Oakton College District 535

Invitation to Bid # 0925-24-03 -Addendum #1
Issue Date: September 25, 2024

Oakton College Des Plaines Adjacencies Renovations - Phase 1

2.) Provide the updated drawing and Project Manual, including responses to the questions submitted by vendors.

8.A12-01

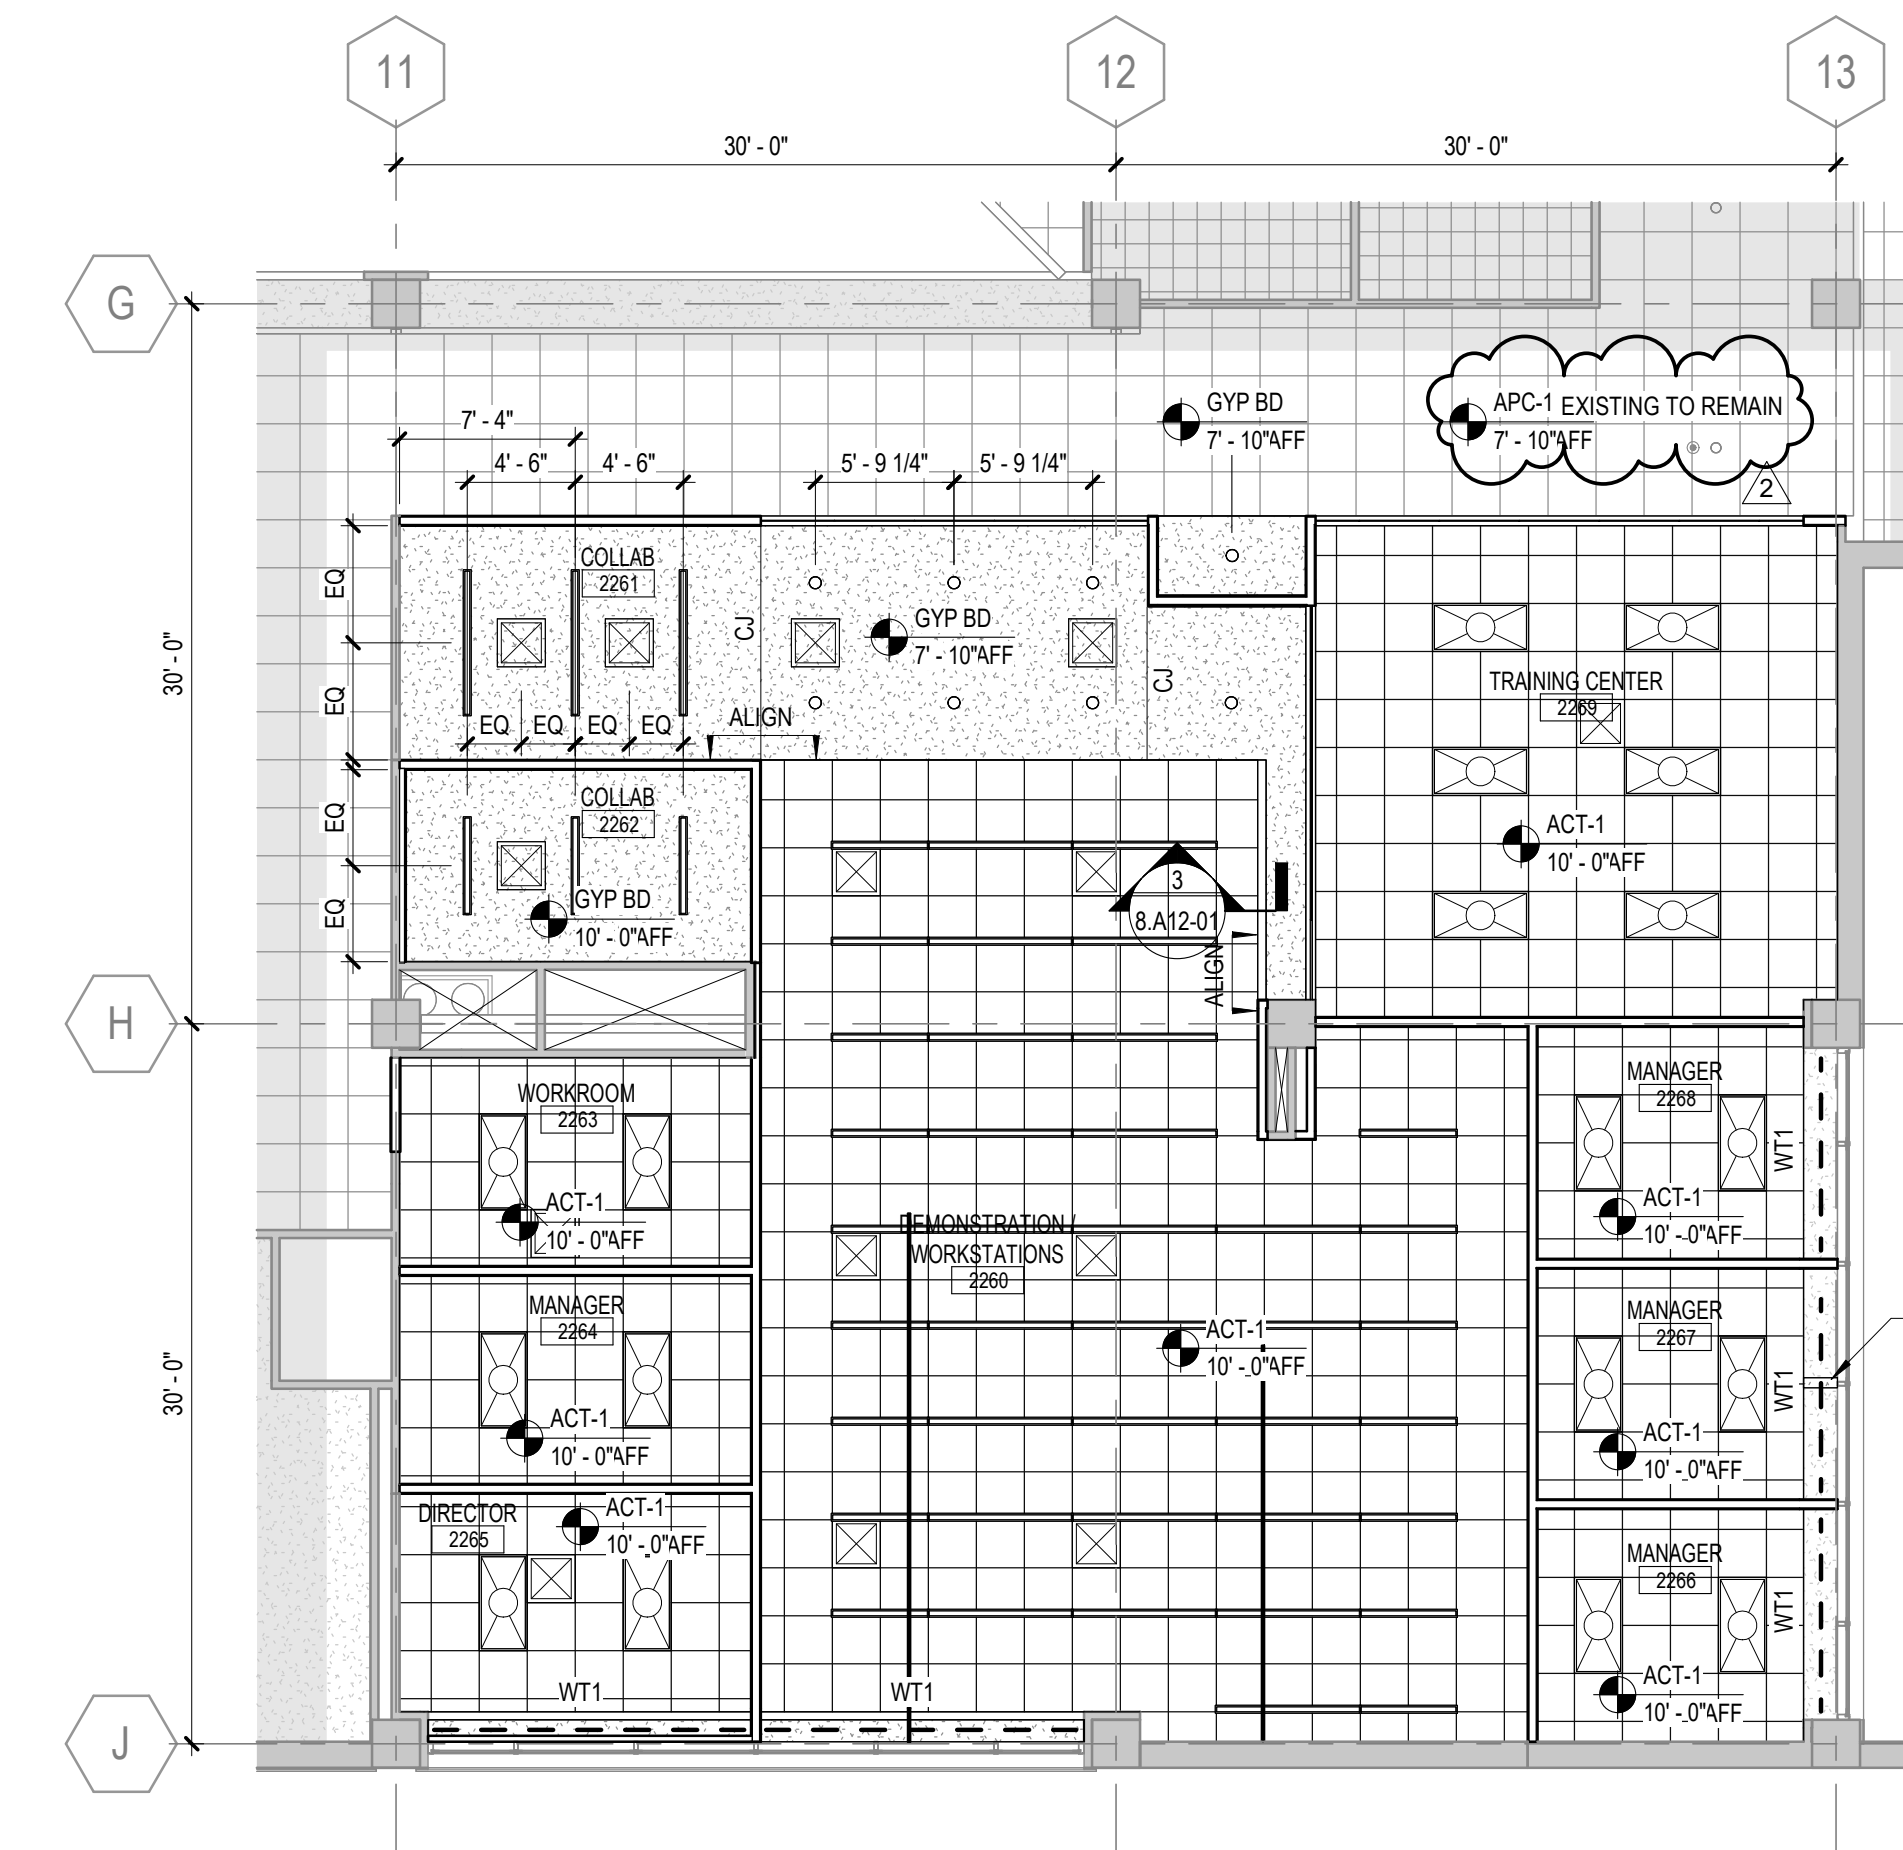
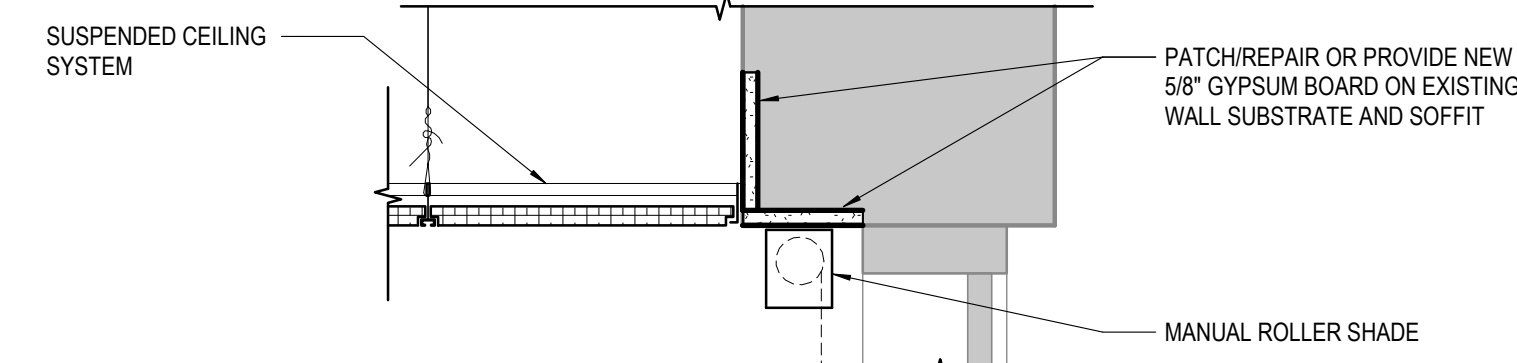
- 5) Revised floor demolition keynotes
 - b. Sheet .8 A11-01 Floor Plans & Floor Details
 - 1) Added wall furring at window
 - c. Sheet .8 A12-01 Reflected Ceiling Plans

- 1) Existing ceiling heights included
 - d. Sheet .8 A62-01 Finish Schedule, Door Schedule, Lites, & Details
 - 1) Door schedule revised
3. Mechanical:
 - a. Sheet M10-01 Mechanical Plan – Phase 1

8. What ceiling removal and reinstallation is required for removing and installing new corridor partitions on drawing A12-01 in detail 2? What is the existing corridor ceiling height? Please clarify.

13. What is the deck height of the 1st and 2nd floor? Please clarify.

A: See revised sheet A12-01 for existing ceiling height.

A: Existing ceiling heights provided on reflected ceiling plans.

8.A62-01

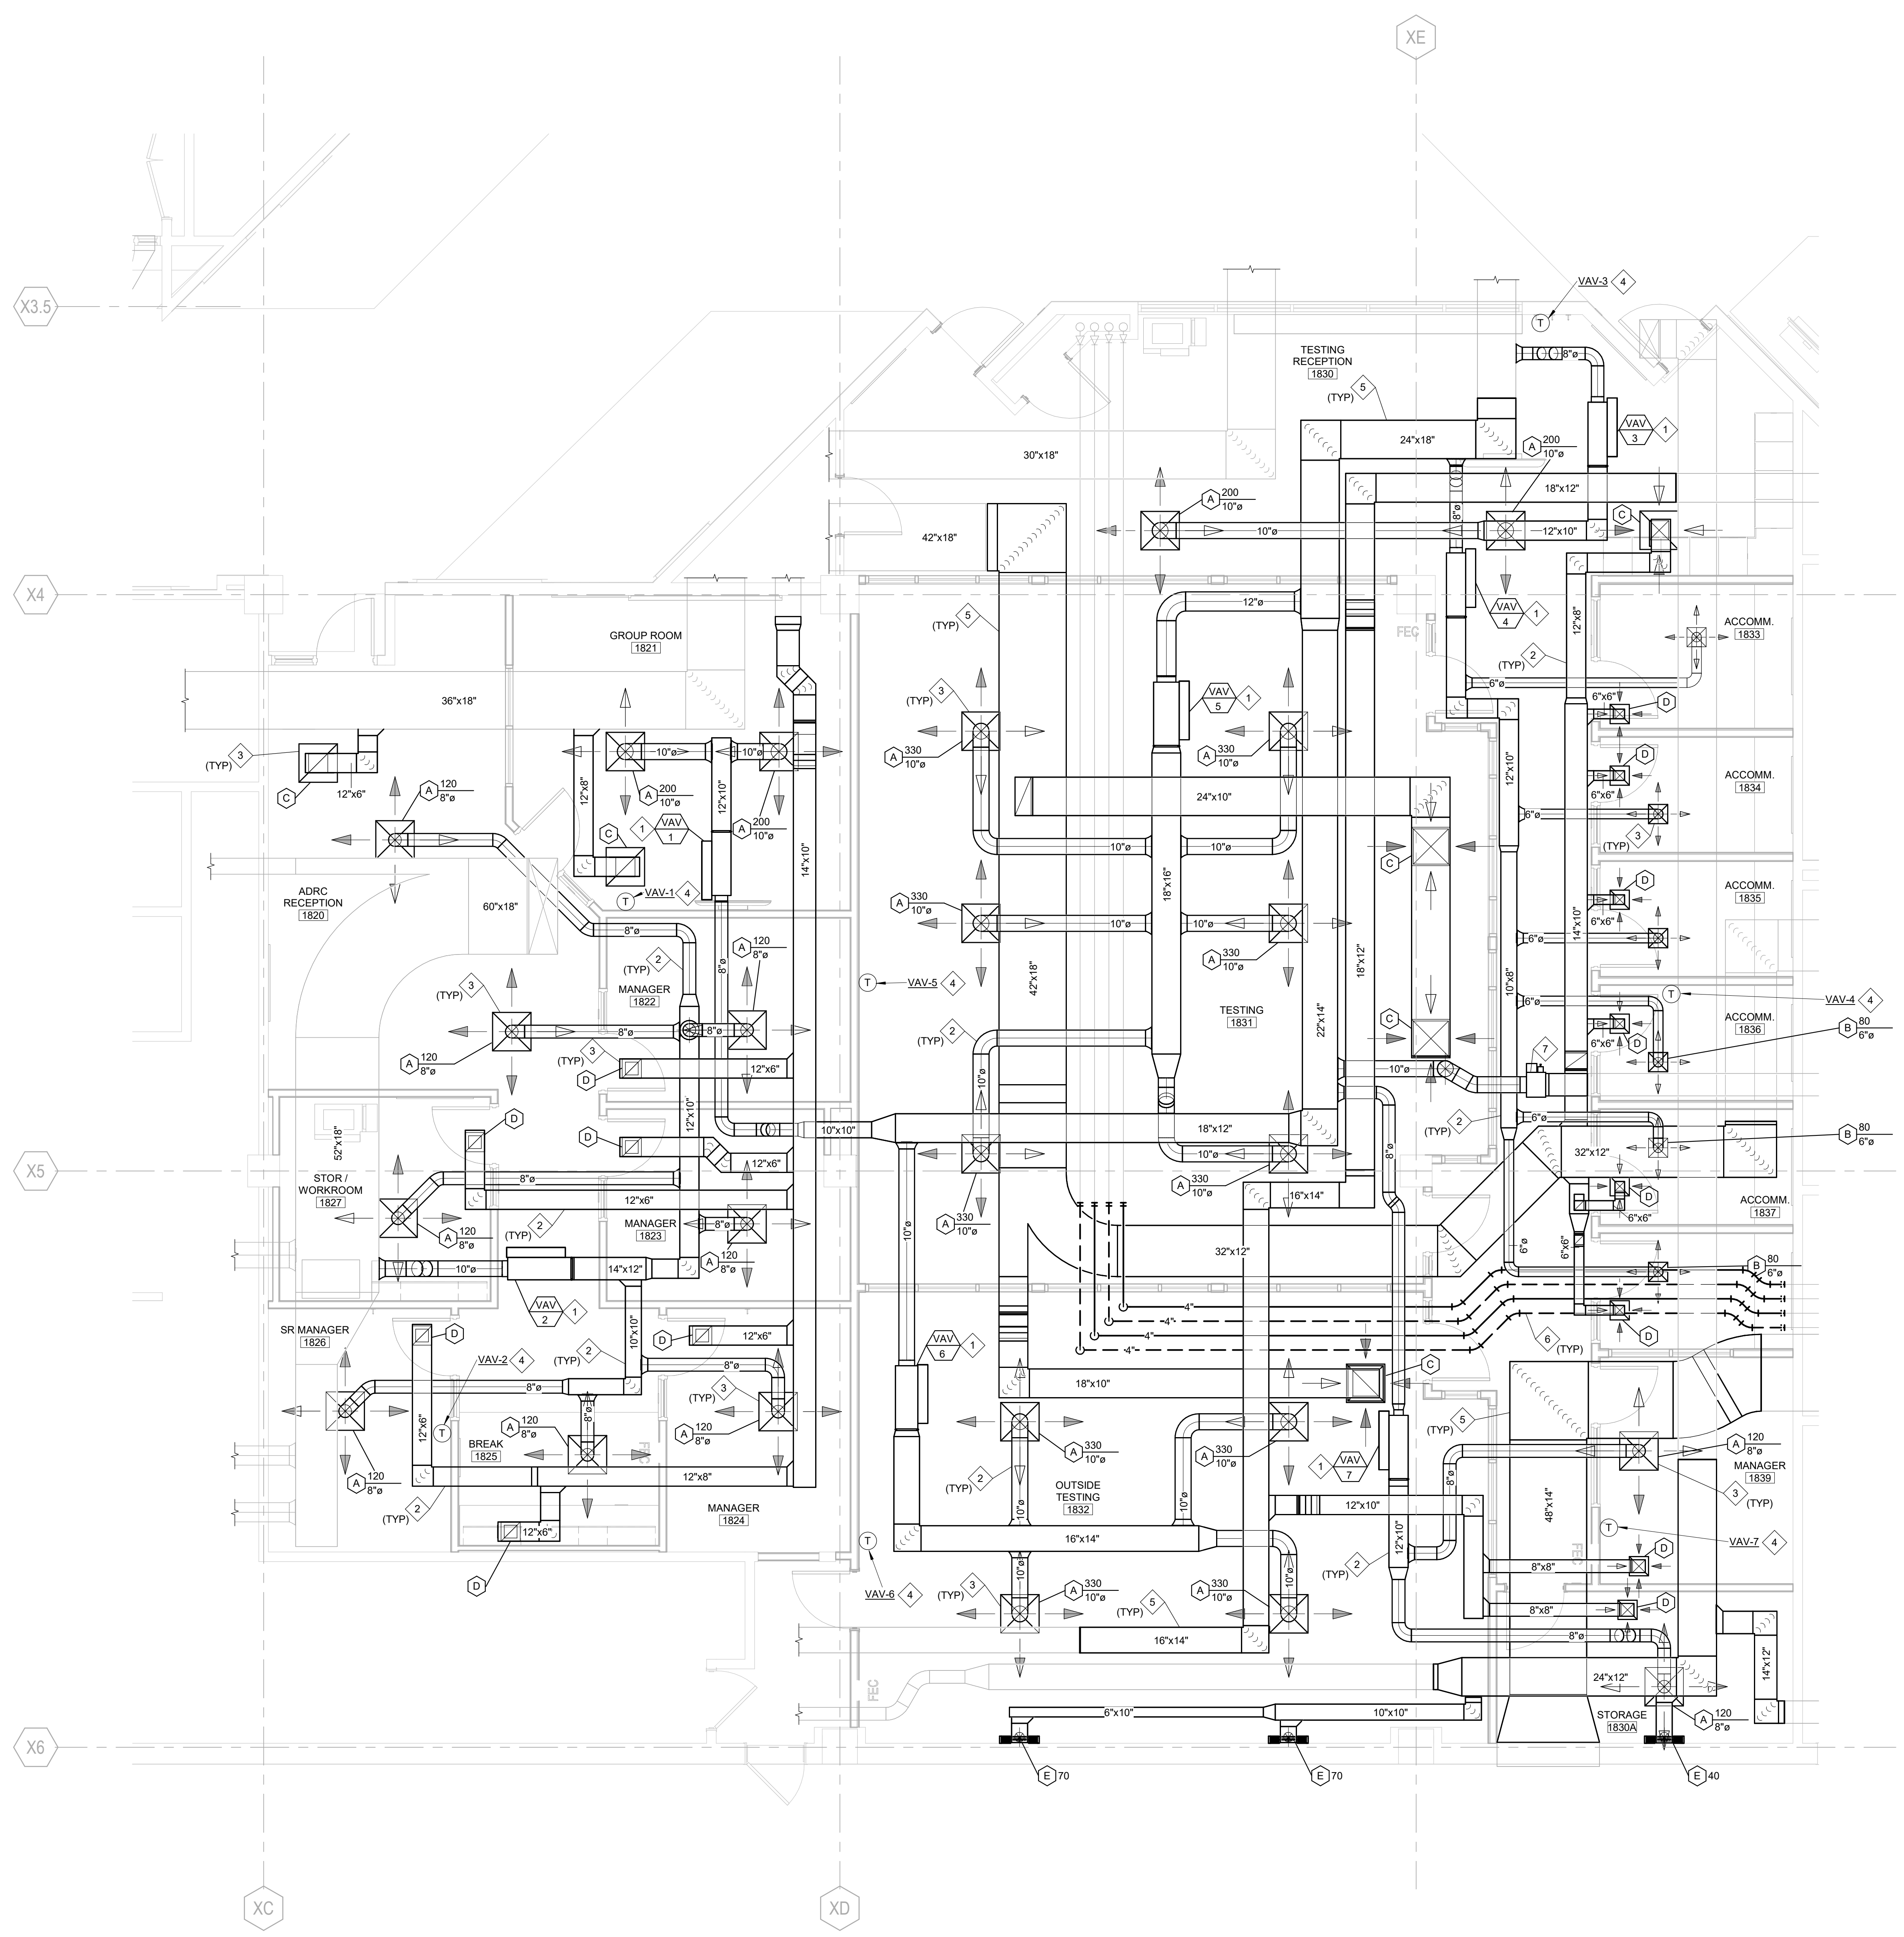
20. Drawing A62-01 has a F2 frame type for door opening 1820.A, but drawing A11-01 shows it having a side lite. What size is the side lite and what type of glass is required? Also, the existing side lite is 6" above finished floor and has terrazzo base installed. What terrazzo patching will be required at this door opening? See attached picture.

A: See revised door schedule on sheet A62-01 and revised demolition plan on A04-01. Existing door frame to remain. Refer to glazing schedule for glazing type.

MECHANICAL PLAN -
PHASE 1

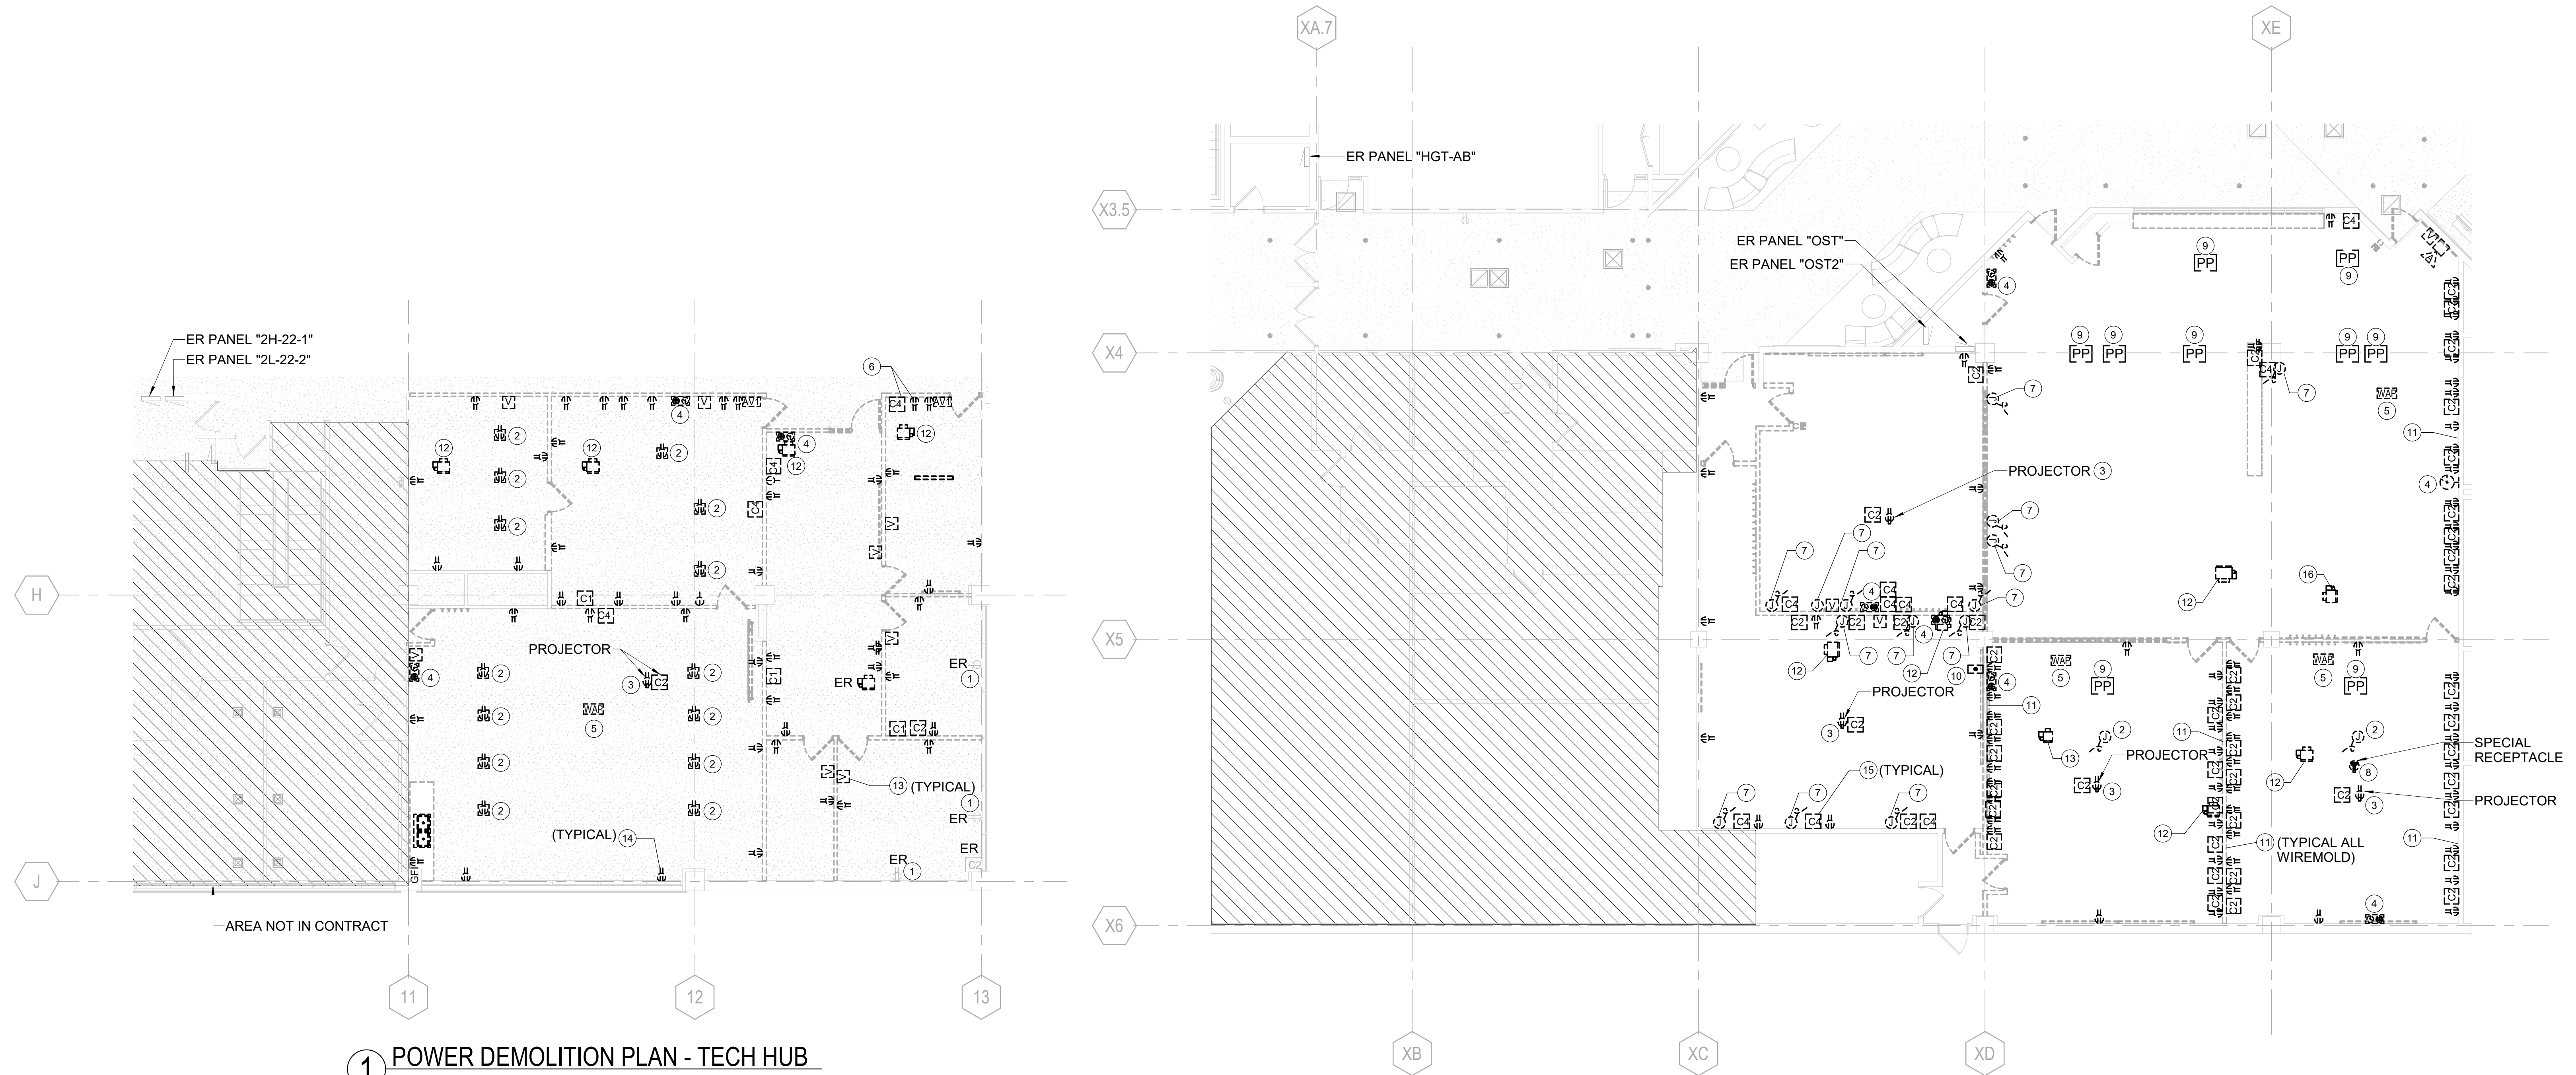
- 1) Revised mechanical installation Note 7. Added relocated VAV equipment data and balance point.
4. Electrical:
 - a. Sheet E04-01 Electrical Demolition Plans – Phase 1

3. Can product data or a serial number be provided for the relocated VAV so that electrical and control work can be priced more accurately?

A: Per existing drawings, relocated VAV is 550 CVM, 8" inlet, Titus DESV, 2 KW reheat, 277V/1PH, with SCR control. Contractor to field verify all data. Contractor to field verify.
